## Temperature Screening MinMoe Terminal Release Notes (2021-11-15)

<b>Device Model:</b> DS-K1T671TM-3XF DS-K1TA70MI-T DS-K5671-3XF DS-K5604A-3XF	Firmware Version	<b>ARM:</b> ACS_671_3XF_AI3_EN_STD_V3.2.32_build211101 ACS_671_3XF_AI3_EN_NEU_V3.2.32_build211101 <b>MCU:</b> ACS_DS-K1T671_ST1_GML_GM_V1.0.1_build210320 <b>Thermal Module:</b> digicap_thermo-en-gm_V5.5.10_build210406
	SDK	Latest baseline
	iVMS-4200 Version	Latest baseline

## Temperature Screening MinMoe Terminal Release Notes (2021-04-02)

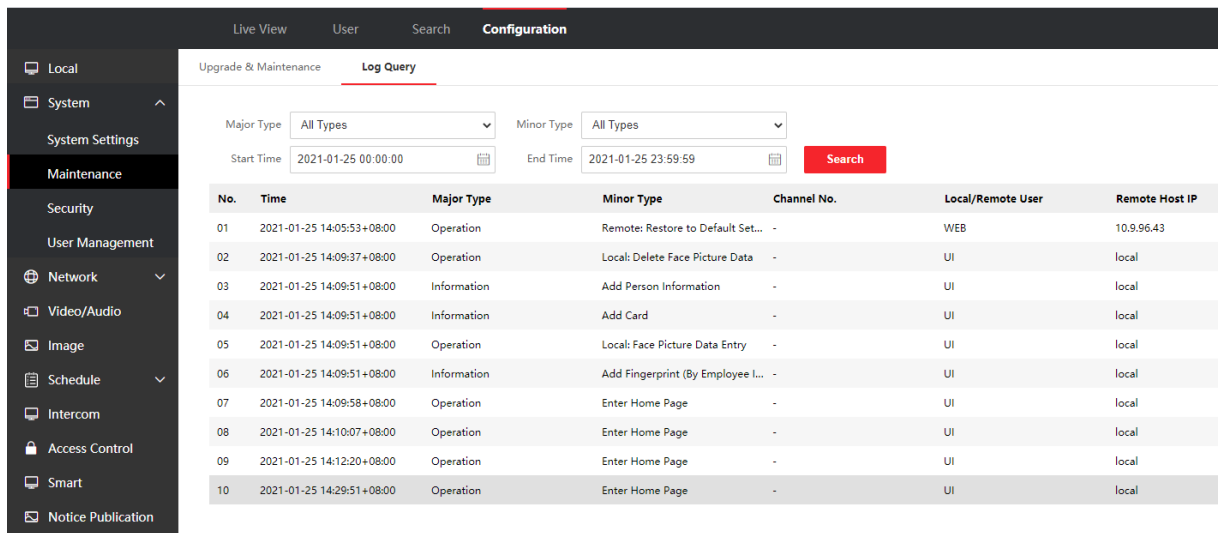
### 3. Add device operation log query function

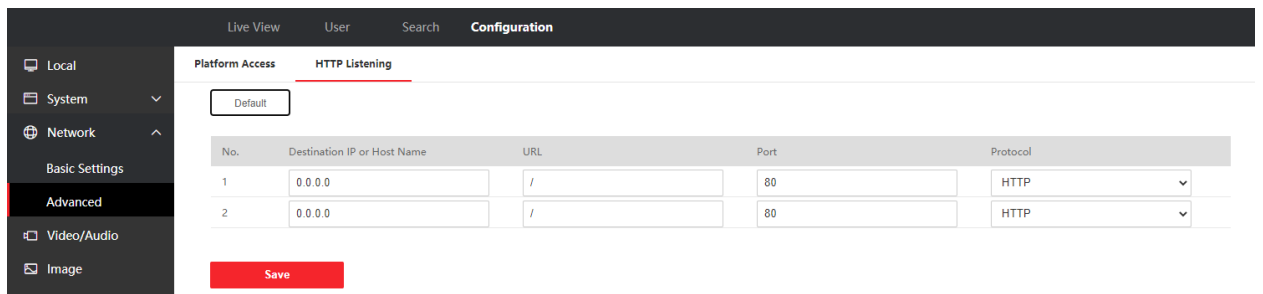
### 4. Add ISAPI event monitoring upload (HTTP/HTTPS listening) function for integration

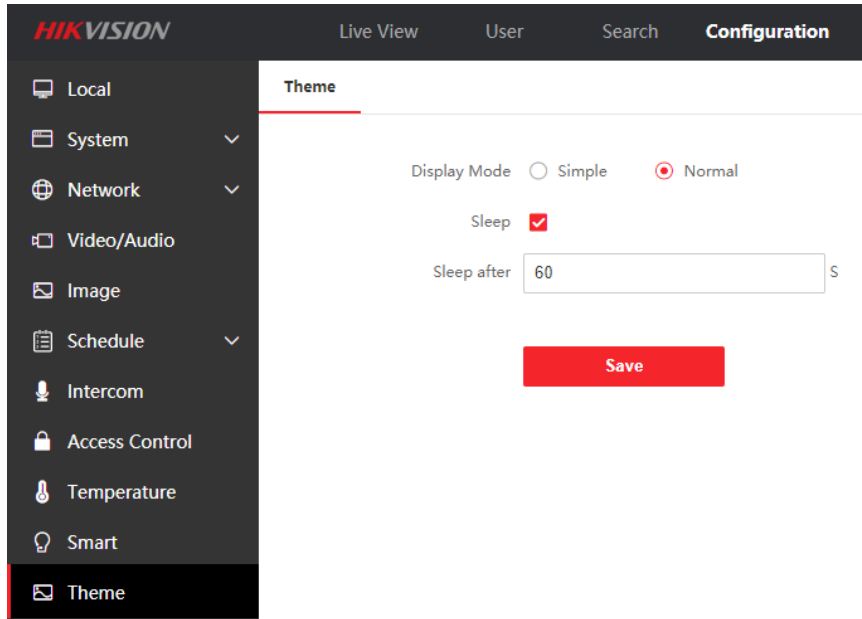
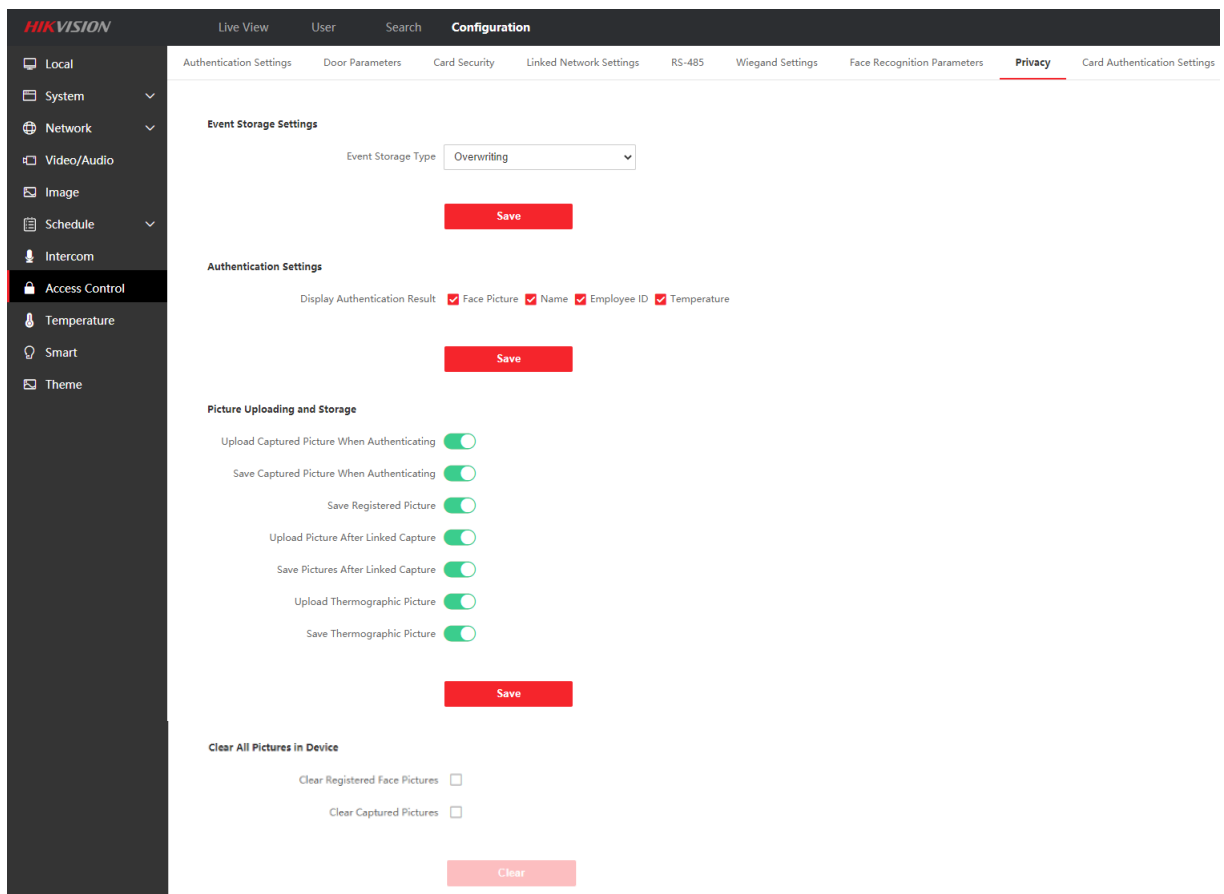
### 5. Add simple mode (disabled in default), after enable, it will not display live view when verify face

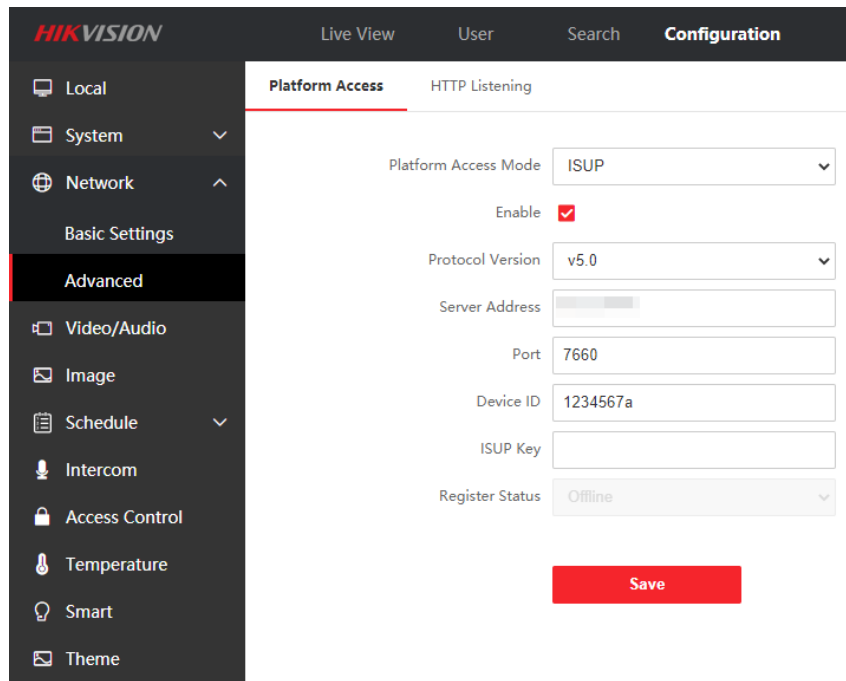
6. Add privacy protection, customer can define the privacy related parameter, such as whether to display photo, name, ID number, temperature after verification, Event Storage Settings, Picture Uploading and Storage, Clear All Pictures in Device

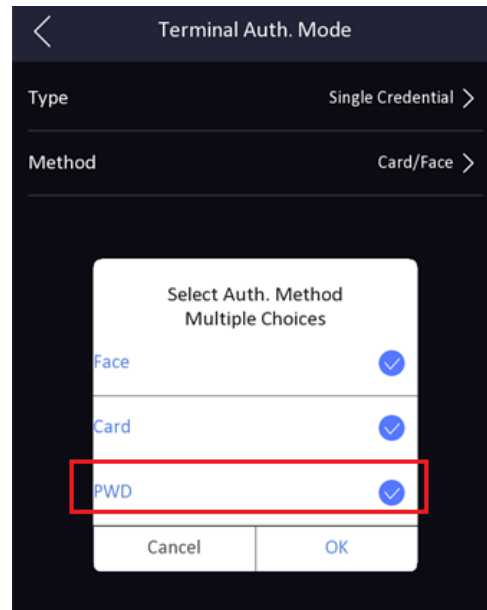
8. Support PIN code only to open the door (disabled in default)

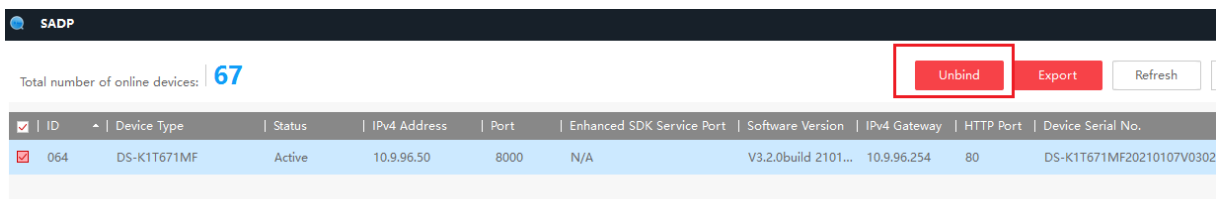
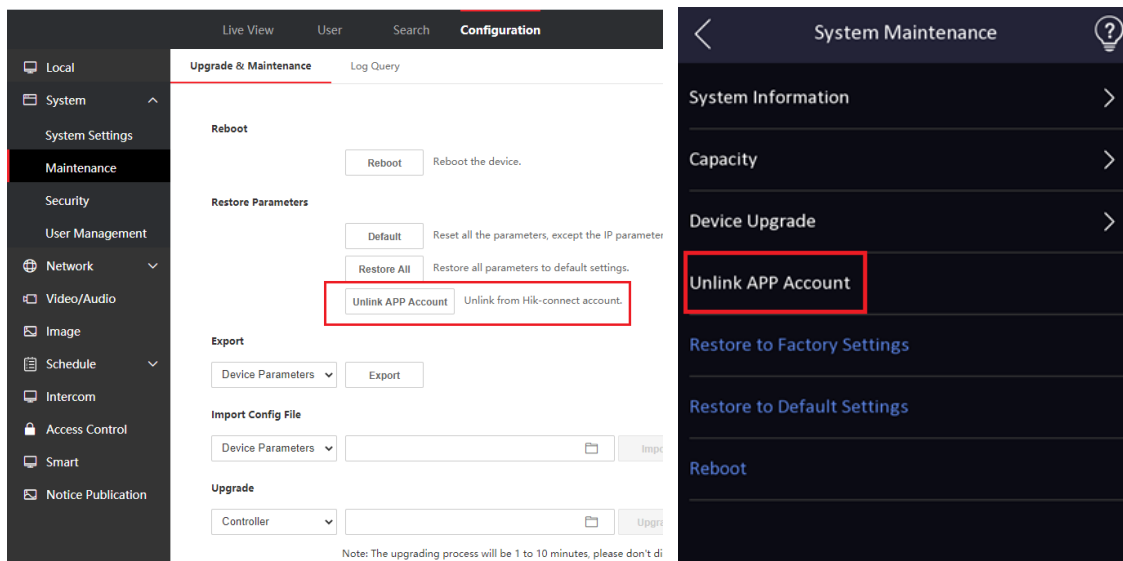
**Note :** PIN code should be configured from software, iVMS4200 already support, HikCentral Pro will support PIN code configuration in V2.1 expected to be released in June

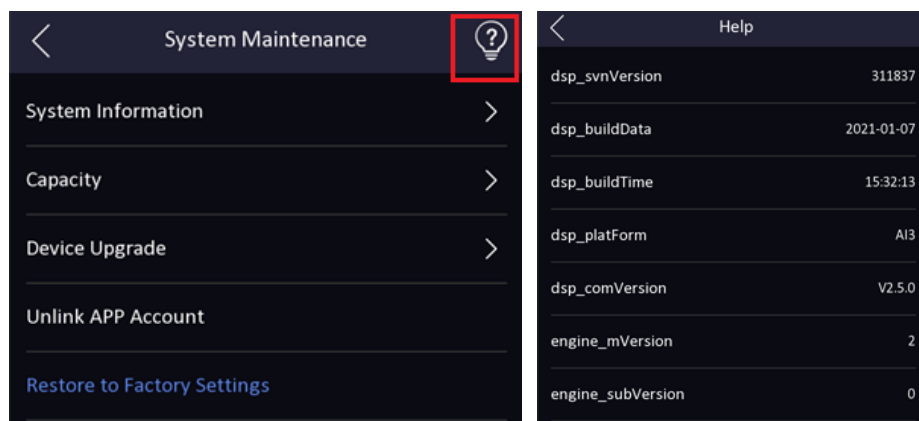
9. Support unbind device with hik-connect account on SADP tool, local UI and web

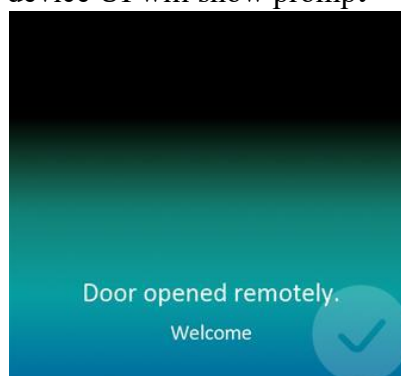
10. Add help interface to check module version for technical support (long press for 3s)

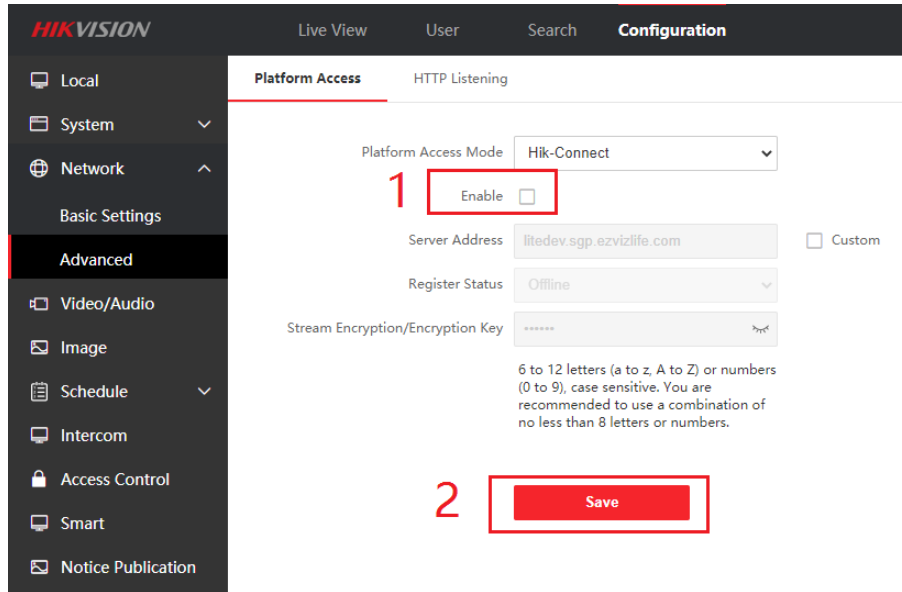
- Upgrade face and mask algorithm. Improve the speed and accuracy of face and dark mask recognition.

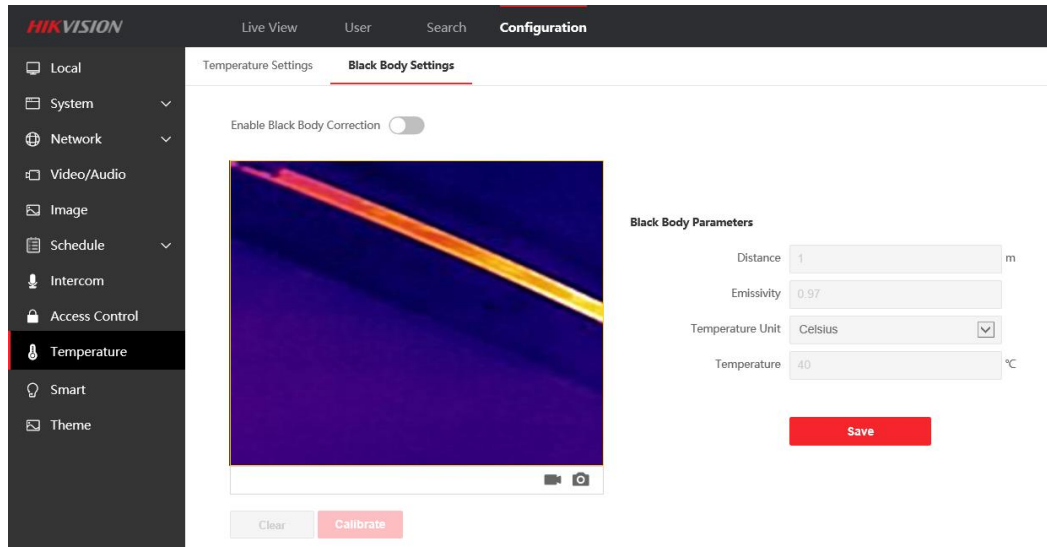
7. Hik-Connect function is disabled in default for privacy protection, if customer want to manage device from App, please turn on manually in the web.
